HORSHAM DISTRICT COUNCIL CONSULTATION

TO:	Horsham District Council – Planning Dept
LOCATION:	Linden Homes Development Site Kings Barn Lane Steyning West Sussex
DESCRIPTION:	Application for Approval of Details Reserved by Condition 18 (underground services) to approved application DC/26/0325 (Removal of conditions 19 (water efficiency measures) and 21 (water neutrality strategy) and variation of trigger of Condition 14 (traffic noise mitigation) of planning approval DC/21/2233 (Outline application for up to 265 dwellings, demolition of No. 37 Kings Barn Lane to provide new pedestrian/cycle/emergency link, provision of vehicular access from the A283 Steyning by-pass. All matters reserved except for vehicular access from A283).)
REFERENCE:	DISC/26/0199
RECOMMENDATION:	Modification
SUMMARY OF COMMENTS & RECOMMENDATION: Adjustments to the proposed services routing are required to allow for the successful delivery of the landscape proposals. This include the relocation of services where necessary, the inclusion of tree root barriers and provision of greater certainty that a key landscape mitigation measure can be implemented. Please see details below.

Sheet 4 of 7

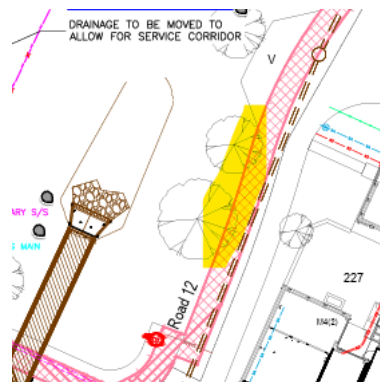
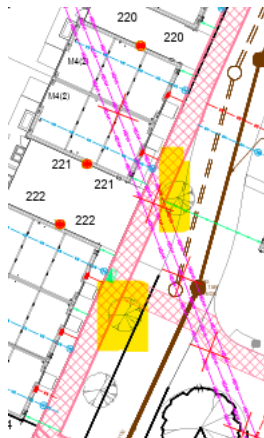
3. As above regarding proximity to tree planting and utility strip. Root barriers must be installed, and it is recommended the location and extent of these are shown in the utilities plan.

Sheet 5 of 7

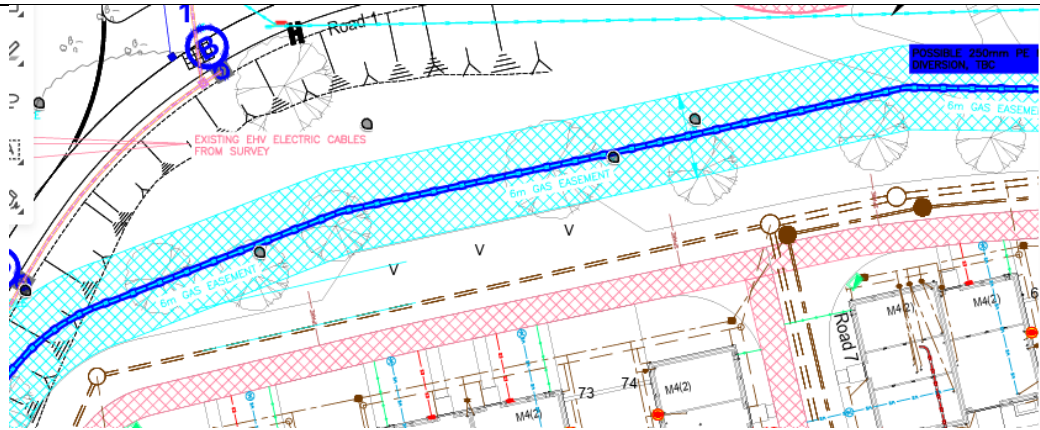
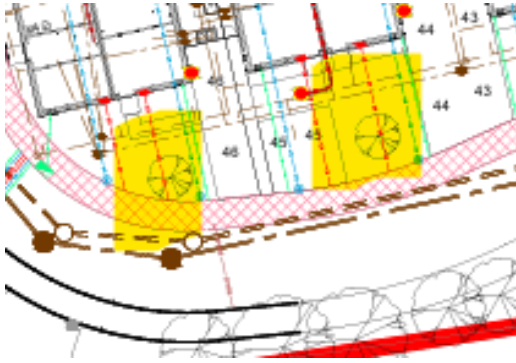
4. There is a significant conflict between the proposed tree planting and what appears to be an existing gas main and associated easement. The note on the plan indicates that this service may be subject to diversion, which would be welcomed so that the tree planting can be delivered in its current location. The planting in this area is a key component of the landscape mitigation strategy, providing important screening and softening the appearance of the development at the site entrance particularly given its elevated position.

While some flexibility in the final positioning of the trees may be necessary while the feasibility of the gas main diversion is explored, the proposed tree planting must remain as close as possible to the currently indicated locations. Should the tree need to be moved considerably further down the bank, additional hedgerow planting along the road hedge may need to be planted to maintain the intended level of landscape mitigation. In that case, revised landscape details should be submitted for approval.

It is recommended that a note be added to the plan stating that, should diversion of the gas main prove unfeasible, revised tree planting locations and shall be submitted to the Council for approval, demonstrating appropriate coordination between the gas main and the landscape proposals.

Alternatively, if there is little certainty that the gas main diversion is achievable, revised tree planting locations should be identified prior to determination.
